REMARKS

These remarks are in response to the telephone call from the Examiner on December 6, 2006, requesting a number of changes be made to the specification and figures of the present application. The subject of telephone call related entirely to a number changes the Examiner felt should be made to the Figures and Specification related either to consistency, spelling, syntax, or other grammatical matters and did not introduce any new matter. It is believed that these have now all been made.

Amendments to the Drawings:

FIG. 2a

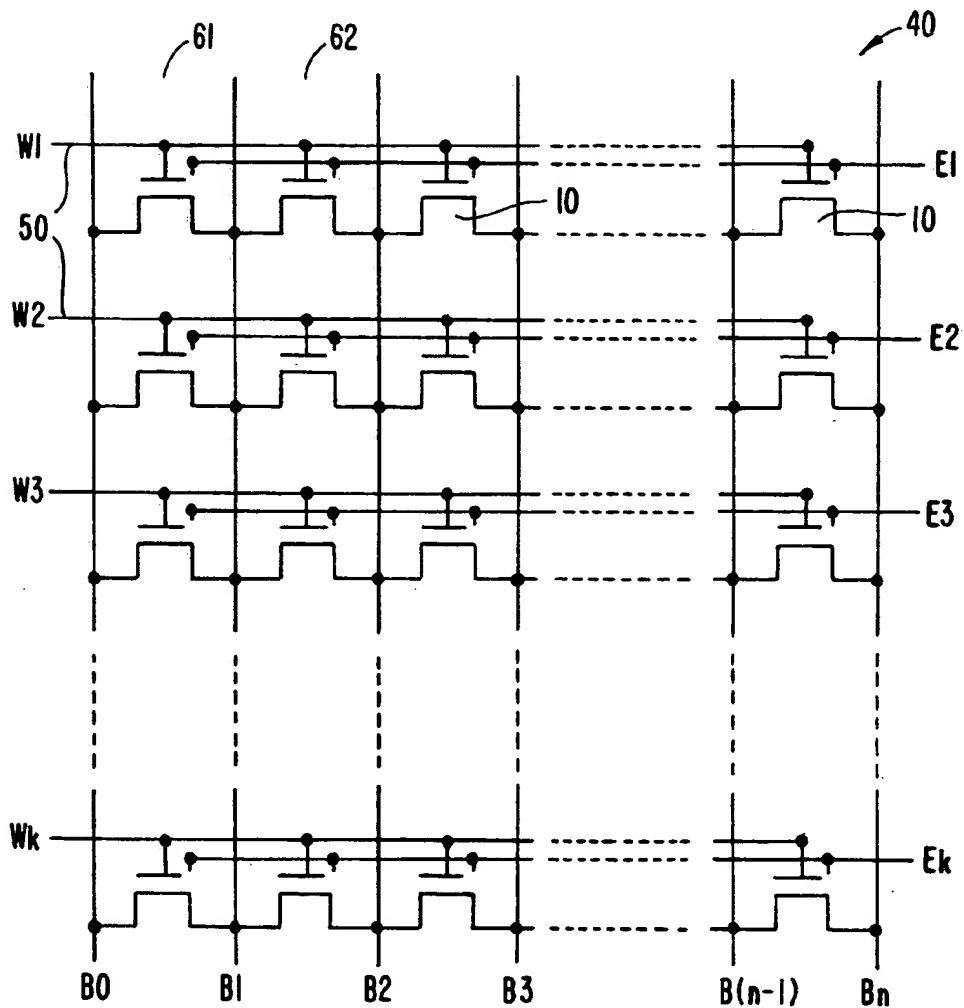
In Figure 2: Please replace “FIG. 2” with --FIG. 2a--.

FIG. 4.

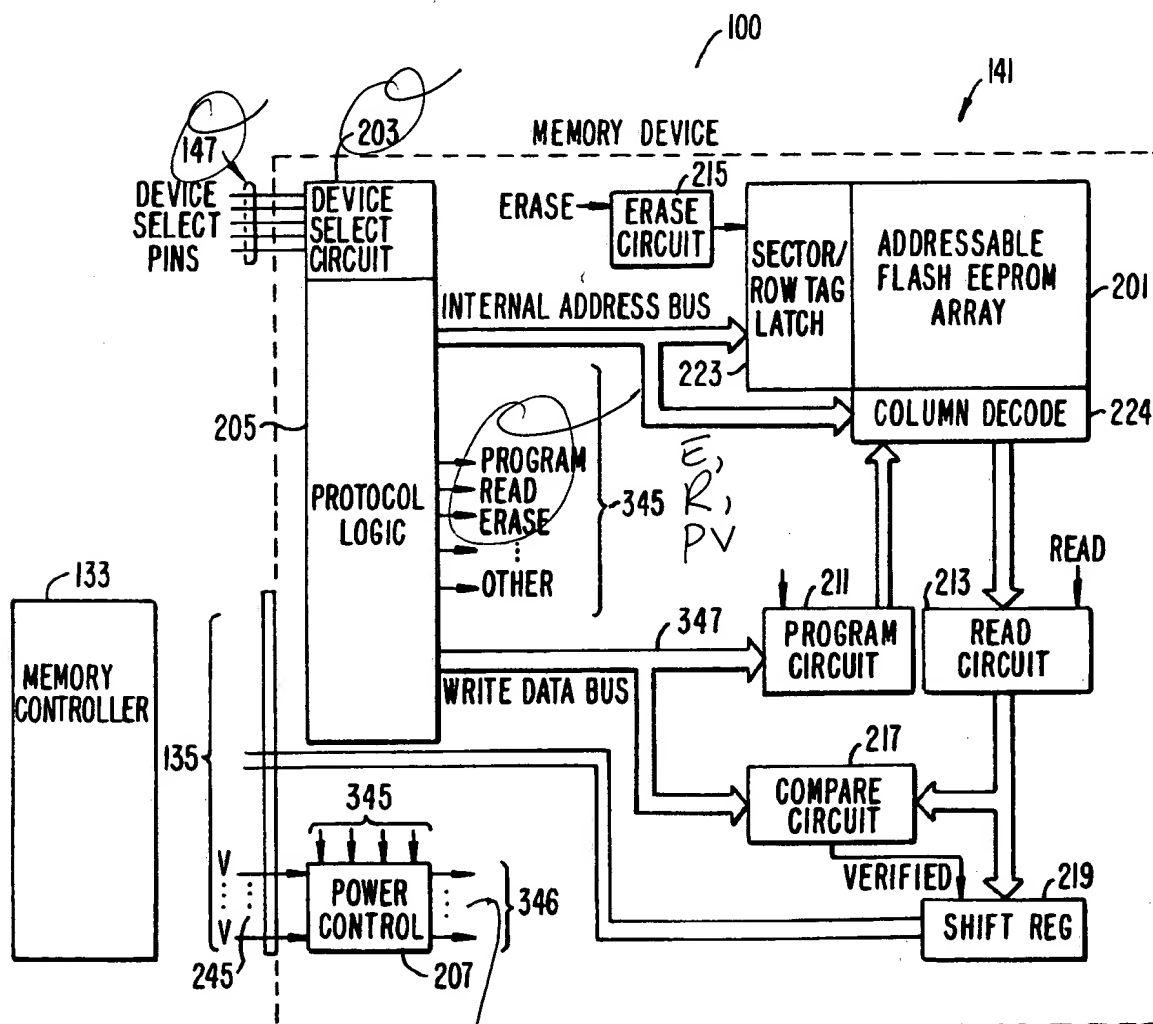
In Figure 4: Please replace “PROGRAM”, “READ”, and “ERASE” at 345 with --E--, --R--, and --PV--, add --V_R-- and --V_{PV}--, and --OTHER— at 346, and delete reference numbers 147, 203, and 347.

FIG. 5.

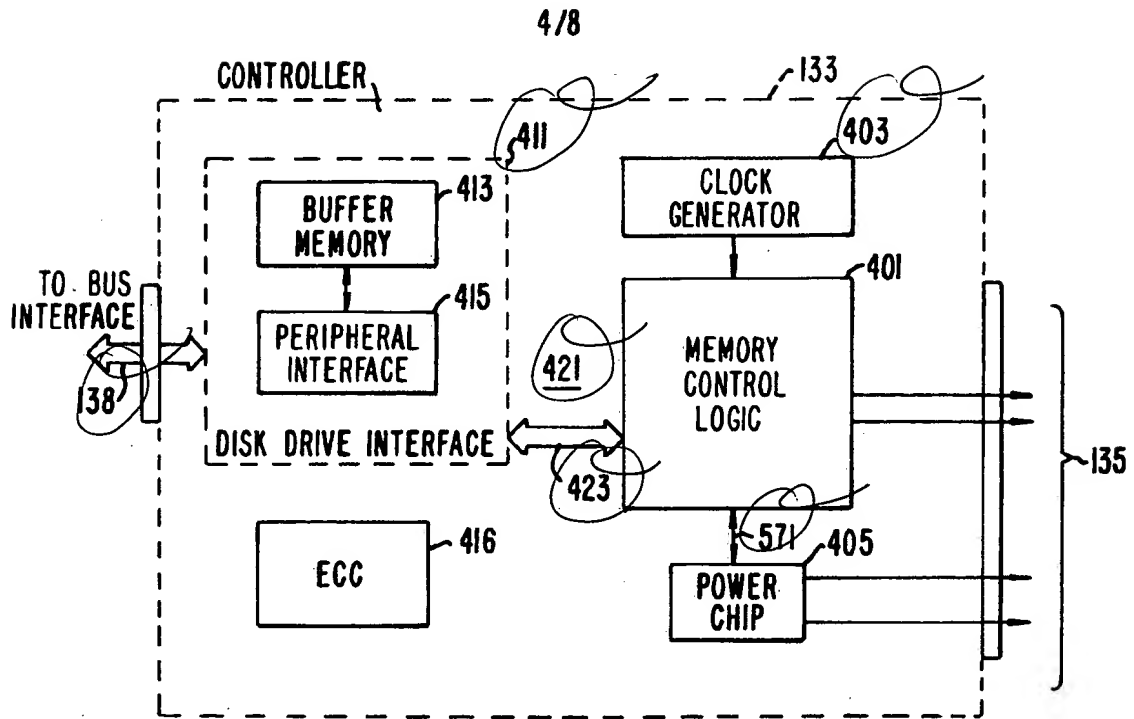
In Figure 5, please delete reference numbers 138, 411, 403, 421, 423, and 571.
